# Staff Report

To: Coalville City Council and Mayor  
From: Don Sargent, Community Development Director  
Date of Meeting: February 23, 2023  
Re: Chalk Creek Estates Phase 4 - MPD Subdivision Final Plat and CD's  
Action: Work Session

## Chalk Creek Estates Phase 4 – MPD Subdivision Final Plat/CD's

## CHALK CREEK ESTATES PHASE 4

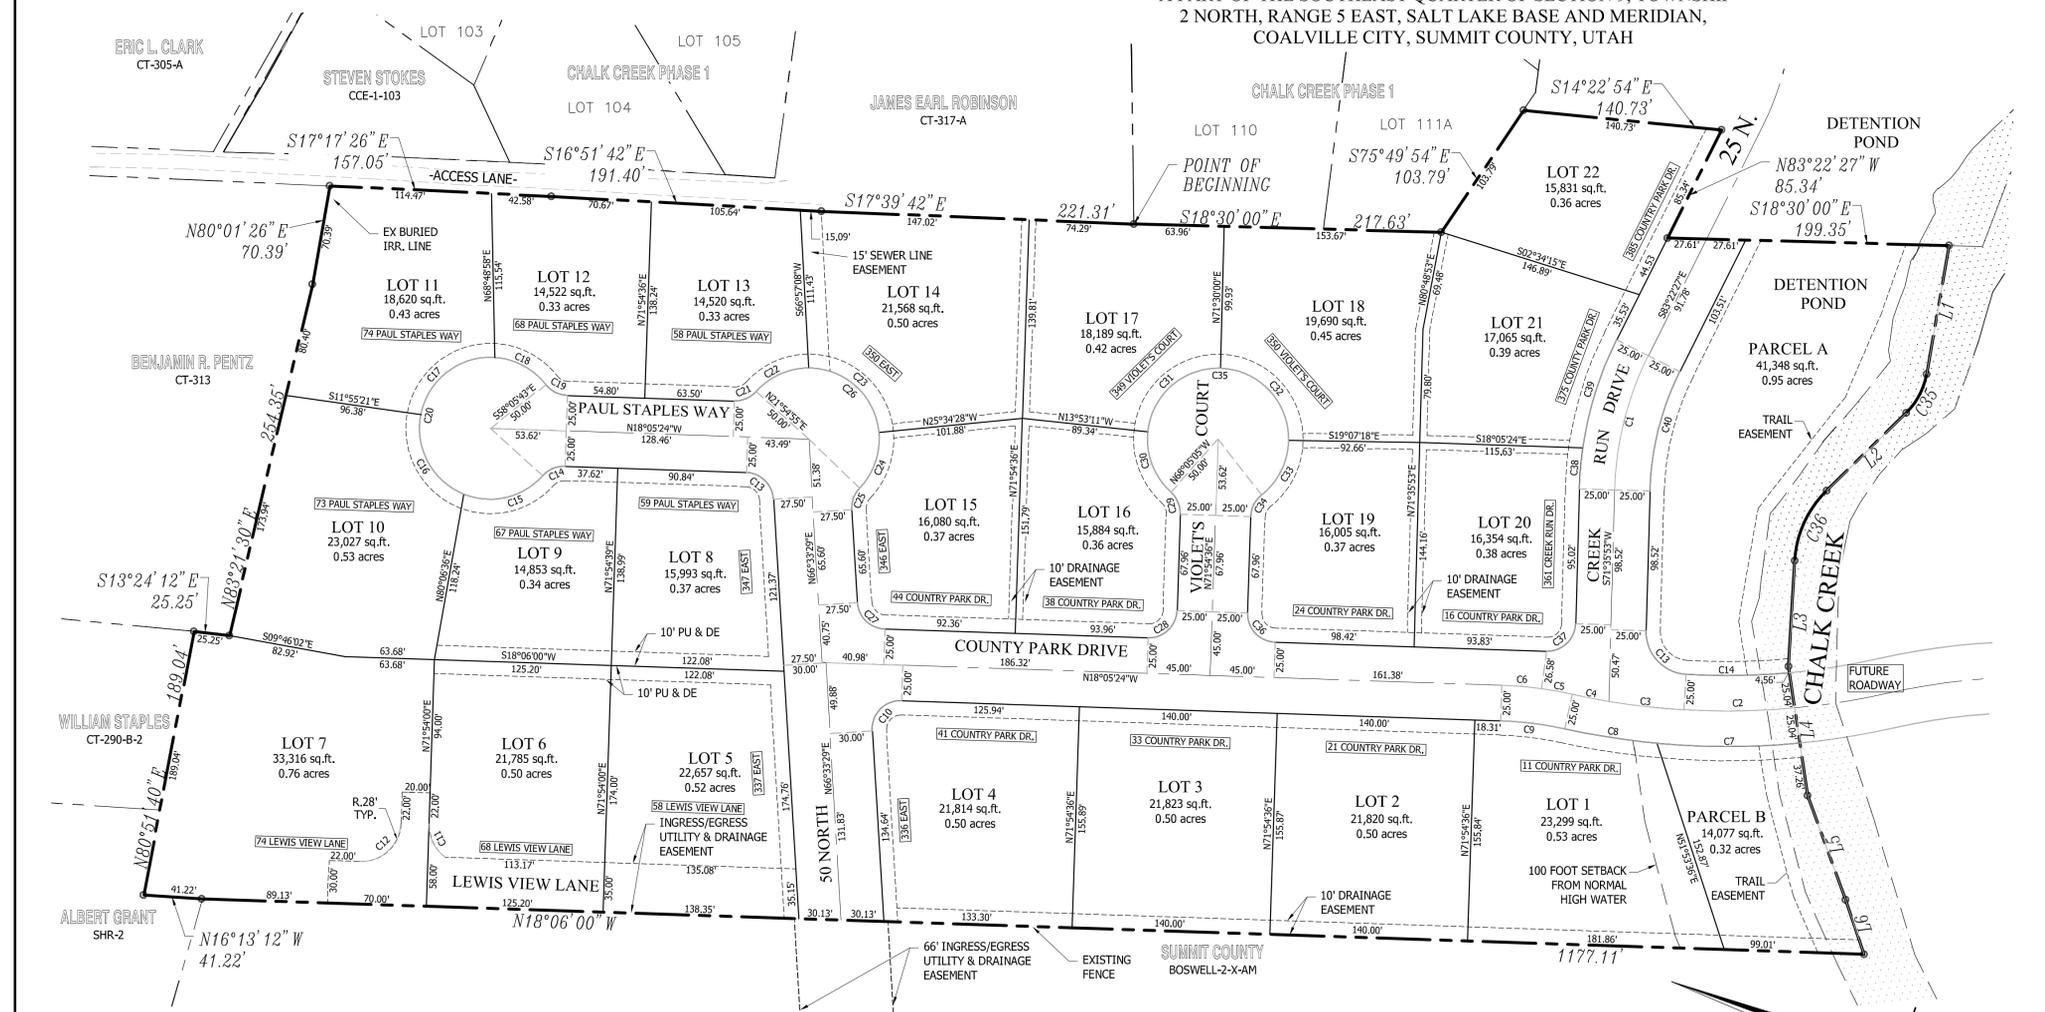
Condition 1. The following note shall be added to the plat to put lot owners on notice that existing farming operations may occur in the surrounding area: “Lot owners of each lot platted in this subdivision and the owner of the residence constructed on a lot have/has been given notice and recognizes that there are active agricultural lands and operations in the surrounding areas and acknowledges and accepts that, so long as such lands and operations exist, there may be dust, odor, prolonged work hours, use of roadways for the purposes of herding/moving animals, and other attributes associated with normal agricultural operations”.

Condition 2. The applicant shall be responsible for the installation and/or construction and on-going maintenance of private recreational improvements for the direct benefit of the development on the park space identified as Parcel A on the subdivision plat as required by Section 8-4-080 of the Development Code. The park improvements shall include 4 picnic tables on 3 concrete pads (it was determined that the proposed dog park be eliminated). The applicant shall provide the proposed park area square footage for verification.

Response: “Lot owners of each lot platted in Phase 4 of the Chalk Creek Estates Subdivision, are to be given notice and recognize that there are active agricultural lands and operations in the surrounding areas and so long as such lands and operations exist there may be dust, noise, odor, prolonged work hours, use of roadways for the purpose of herding/moving animals, and other attributes associated with normal agricultural operations.” (Final construction drawings-Sheet 3-Note 3)

Response: We are planning to install and/or construct the following recreational improvements on the park space identified as Parcel A.

- (2) 13'x16' concrete pads with (1) picnic table per pad and 5' wide connecting walkways. (Final construction drawings-Sheet 4-Note #40)
- (1) 22'x16' concrete pad with (2) picnic tables and a 5' wide connecting walkway. (Final construction drawings-Sheet 4-Note #61)
- The square footage of Parcel A is 41,348 sq'.
